Evaluation of the Tailings Dam, Cyanide Use and Water Consumption at the Proposed Volta Grande Gold Project, Pará, Northern Brazil

Steven H. Emerman, Ph.D., Malach Consulting, LLC, 785 N 200 W, Spanish Fork, Utah 84660, USA, Tel: 1-801-921-1228, E-mail: SHEmerman@gmail.com

Report written at the request of Amazon Watch, submitted June 1, 2020

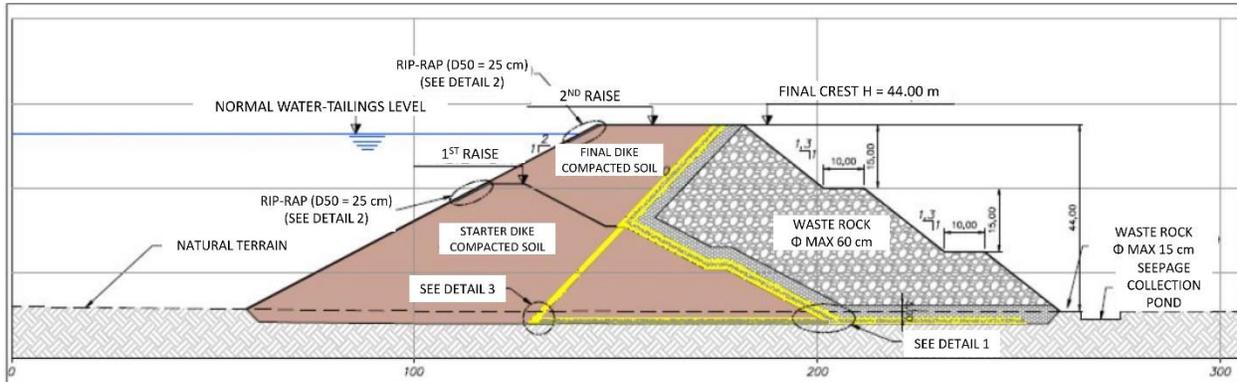
The tailings dam for the Volta Grande Project would be constructed in two stages using the downstream construction method (see Figs. 6b and 8). The starter dike would be constructed out of compacted soil from the project site to a height of 26.5 meters. The final dike would be constructed out of compacted soil on the upstream side and mine waste rock on the downstream side to a final height of 44 meters (see Fig. 8). Before export to the tailings pond, the cyanide would be destroyed using sulfur dioxide and the tailings would be thickened to a solids content of 53% by weight. The tailings dam would have zero downstream discharge in that all seepage from the dam would be pumped back into the tailings pond (Brandt Meio Ambiente, 2016a; VOGBR, 2016a).

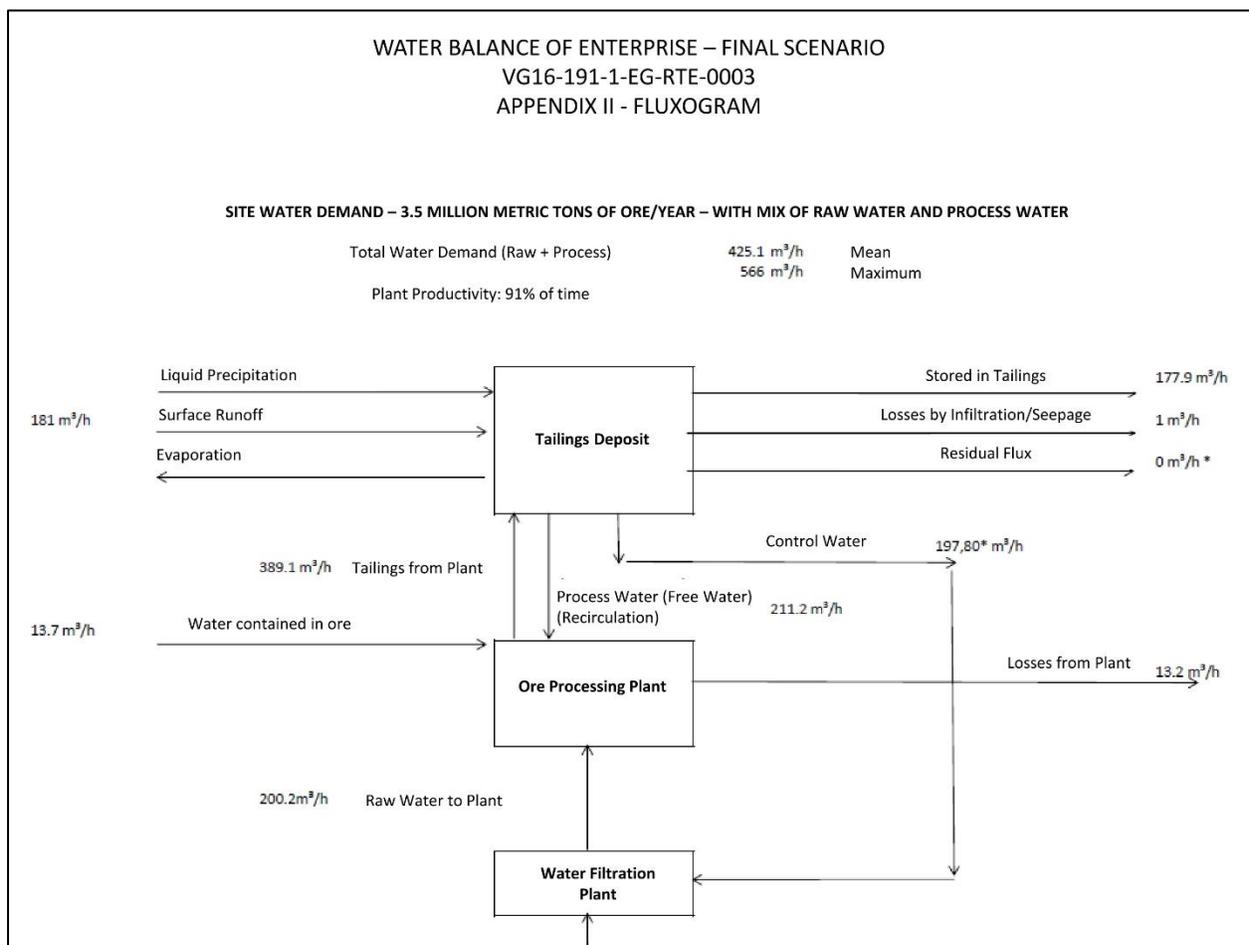
Although the predicted water consumption of the Volta Grande Project seems perfectly reasonable, it is important to consider how the water economy is achieved. The tailings deposit will receive both water (the spent cyanide leach) from the ore processing plant and the surface runoff from the watershed (see Figs. 3 and 10). Out of the free water that accumulates in the tailings deposit, 211.2 cubic meters of water per hour would be pumped back into the ore processing plant without water treatment and 197.8 cubic meters of water per hour would be pumped through a water filtration plant for removal of sediment before pumping to the ore processing plant (VOGBR, 2016b; see Fig. 10). The result of the use of the tailings deposit as, essentially, a water storage pond, is that there would always be free water on top of the tailings (see Fig. 11a) with 7 meters of free water by the end of the mining operation (see Fig. 11b). As a consequence, almost all of the tailings would be saturated with water (see Fig. 12a). Out of the 35.43 million cubic meters of tailings and water that would remain at the end of the mining operation, 32.36 million cubic meters would be saturated tailings, while 3.07 million cubic meters would be free water on top of the tailings (Brandt Meio Ambiente, 2016b).

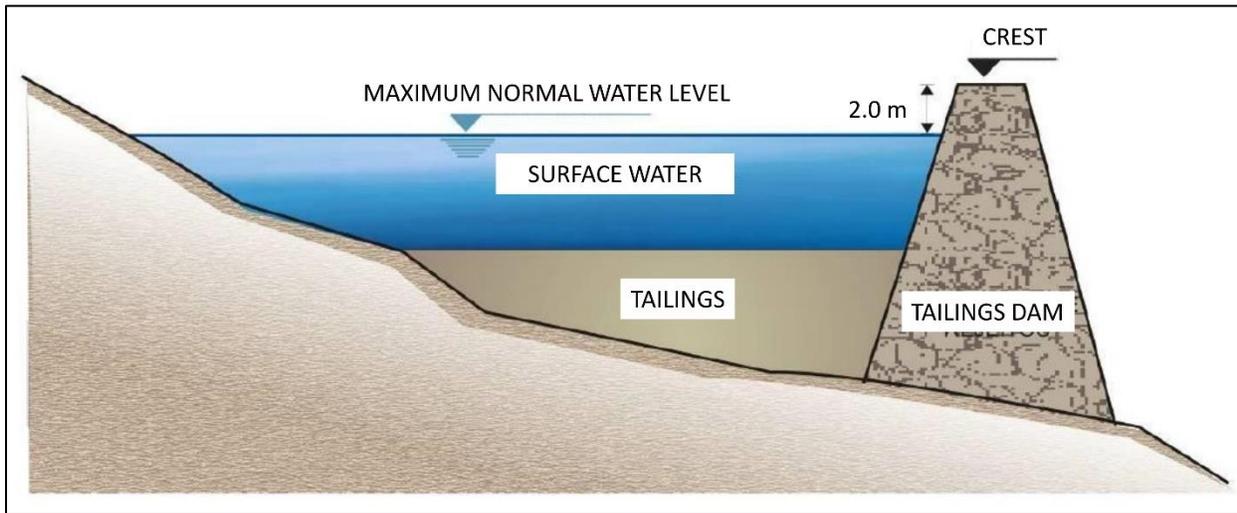
The use of the tailings deposit to capture surface runoff is a very unusual practice at the present time. In fact, it is far more common to construct a system of diversion channels to prevent the entry of catchment water into the tailings deposit in order to reduce the water content of the tailings (Vick, 1990). The mining company does plan to thicken the mixture of tailings and water to a 53% solids content before export to the tailings deposit. However, the addition of 181 cubic meters of water (surface runoff + precipitation – evaporation) for every 389.1 cubic meters of water from the ore processing plant (see Fig. 10) would give the mixture of tailings and water an effective solids content of 43%, which is within the range for conventional tailings management with no thickening.

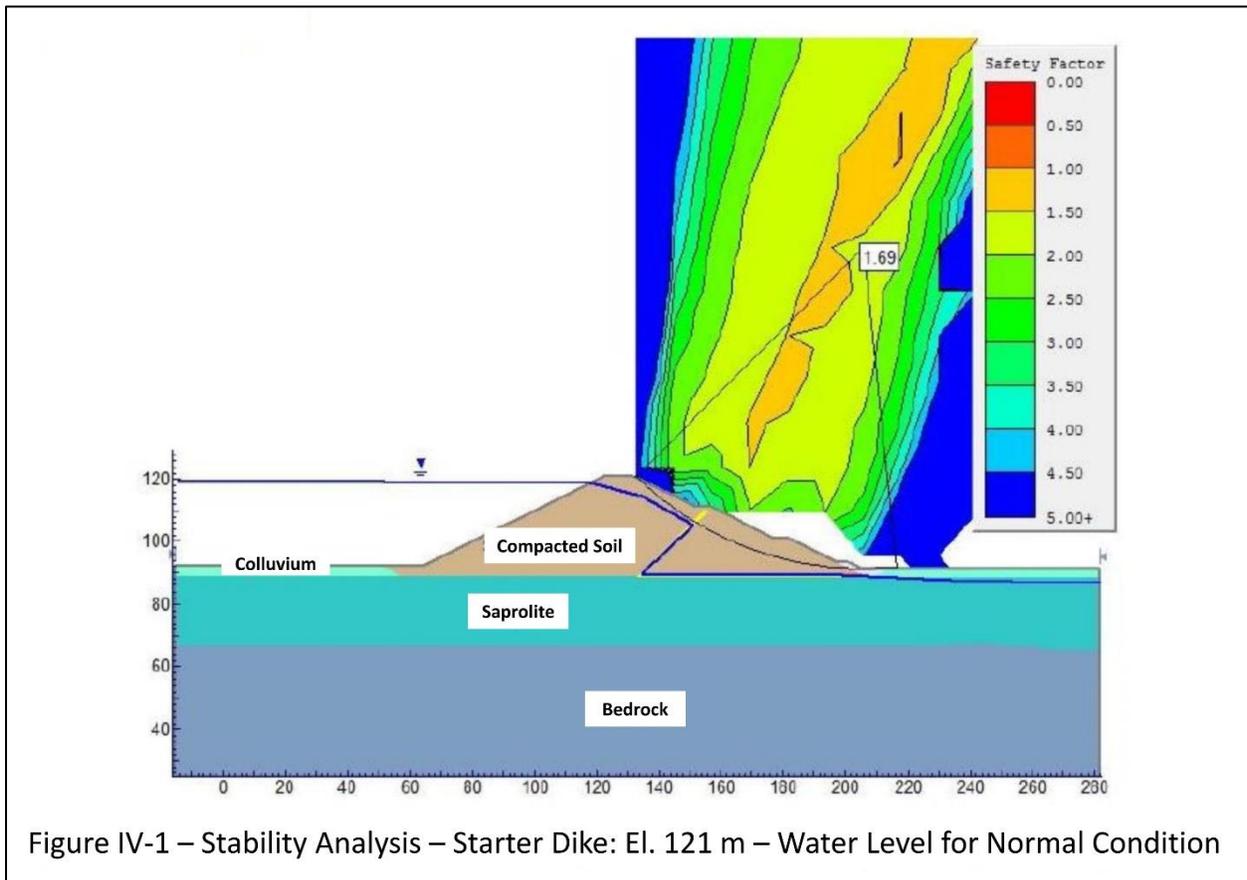
Based upon the geometry of the tailings deposit, an assumed water table height, and the geotechnical parameters of the compacted soil and the foundation, the starter dike would have a factor of safety of 1.69 against failure by slumping or sliding (see Fig. 12a), which is reasonably greater than the minimum value (1.50) required by Brazilian tailings dam regulations (ABNT, 2017). The internal drainage system (yellow lines in Figs. 8 and 12a) would clearly play a critical

role in lowering the water table within the tailings dam (although not in the tailings stored behind the dam). Any failure of the internal drainage system that would allow the water table to rise about one-half the dam height on the downslope side of the starter dike would cause the factor of safety to drop below the minimum acceptable value (see Fig. 12b). I have not seen any document that carries out the same stability analysis for the final dike.

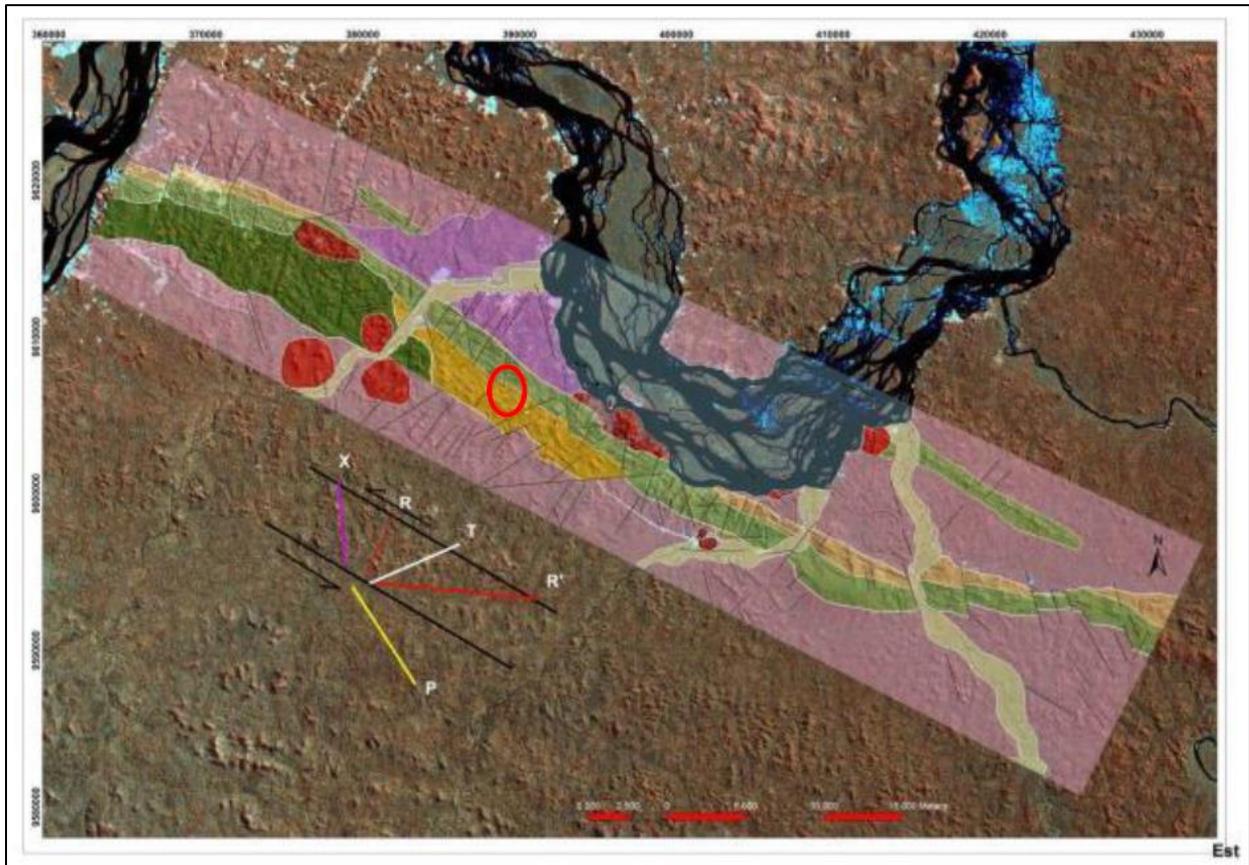
It is most disturbing that the existing stability analyses were carried out only under static conditions and not under the condition of a design seismic acceleration. In fact, none of the documents of the 2016 EIS discuss a design earthquake or include any analysis of local or regional seismicity. This is surprising because the documents show maps of faults and fractures in the vicinity of the mining project site, including three possible faults intersecting at the exact site of the proposed tailings dam (see Figs. 13a-b; VOGBR, 2016a). However, these faults were discussed only in terms of their ability to transmit seepage of water from the tailings deposit, and not in terms of their ability to act as sources of seismicity.

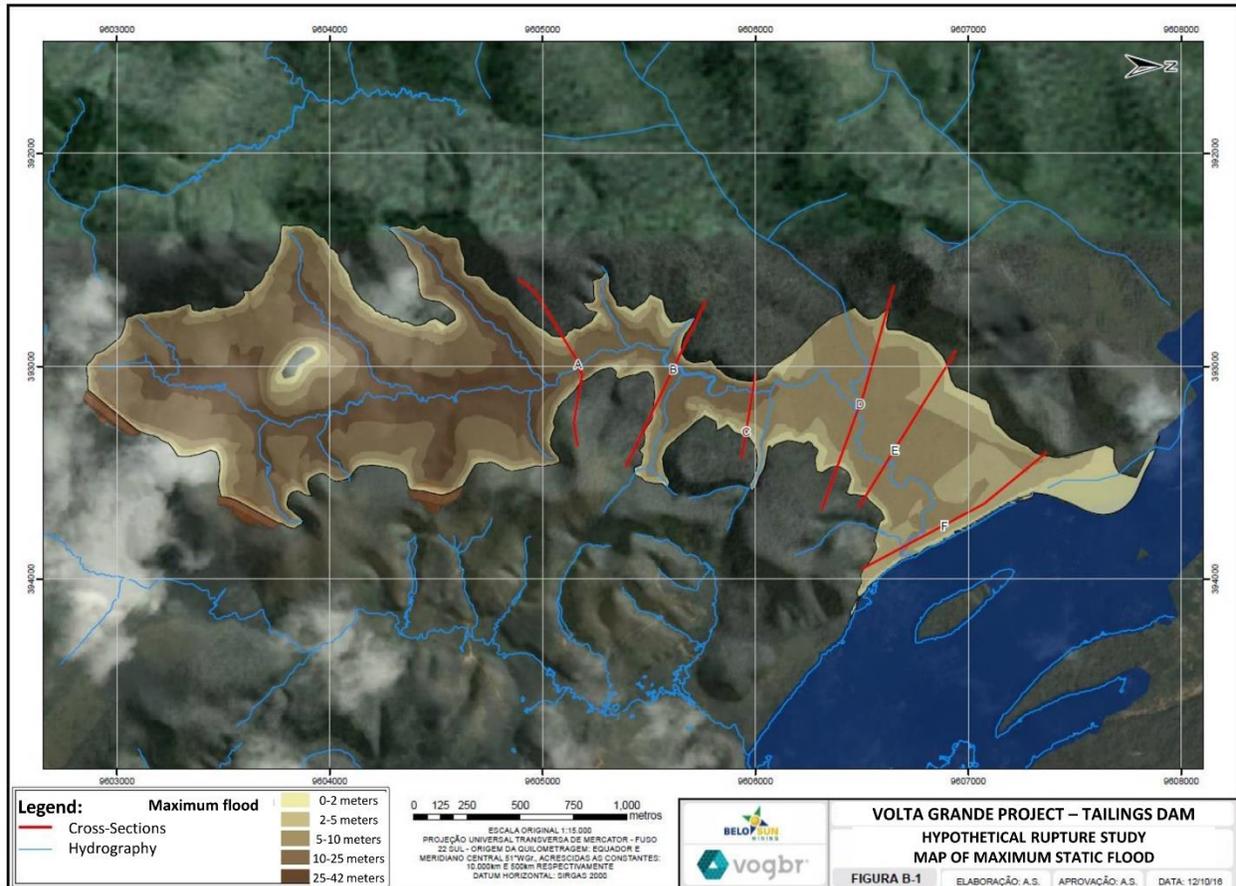
It is difficult to reconcile the above results with the conclusions reached by Brandt Meio Ambiente (2016a). According to the 2016 EIS, the tailings flood would reach the banks of the Xingu River in 97 minutes, corresponding to a tailings flow velocity of 1.4 kilometers per hour. The above velocity is quite slow. The vast majority of streams at flood stage have velocities in the range 4-11 kilometers per hour (Leopold, 1994). No available document has explained the details of the calculation. However, a hint is given in Brandt Meio Ambiente (2016a), which lists as one of the assumptions of the calculation “*Critério de parada: atingir o Rio Xingu* [Stopping criterion: Reaching the Xingu River] (see Fig. 14). There is no physical basis for the assumption that the tailings would come to a stop upon reaching the Xingu River, especially not a river with a minimum discharge of 700 cubic meters per second (Higgins, 2020).
